Service Bulletin

82-S0515

Room Slide Control Replacement (Installation Instructions)

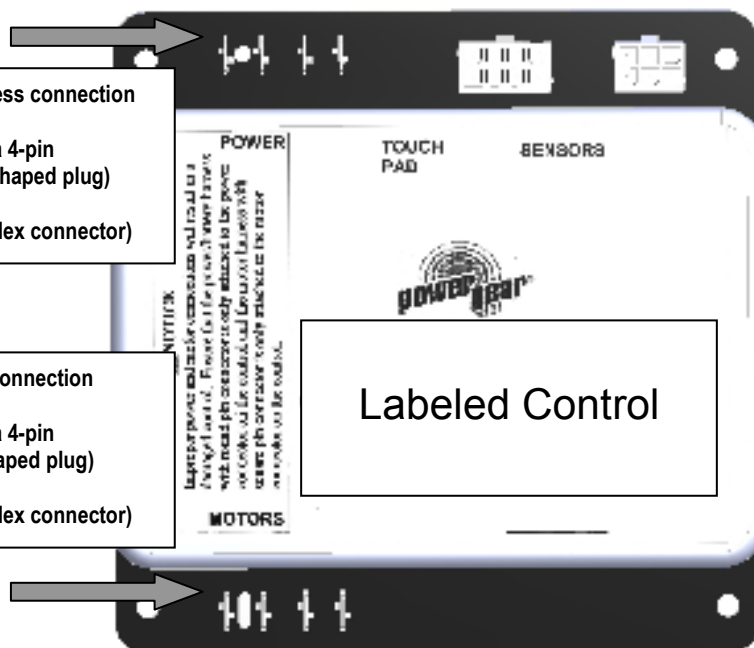
The battery (power) and motor harness receiving hole connection points (located between the 1st and 2nd blade connectors) are identified on the decal located on the control to ensure proper installation.

Battery (power) harness connection

(MY'09 and prior uses a 4-pin connector with round shaped plug)

(MY'10 uses a 4-pin Molex connector)

Motor Harness Connection

(MY'09 and prior uses a 4-pin connector with oval shaped plug)

(MY'10 uses a 5-pin Molex connector)

For ease of installation, and to ensure proper connection, replace one harness at a time.
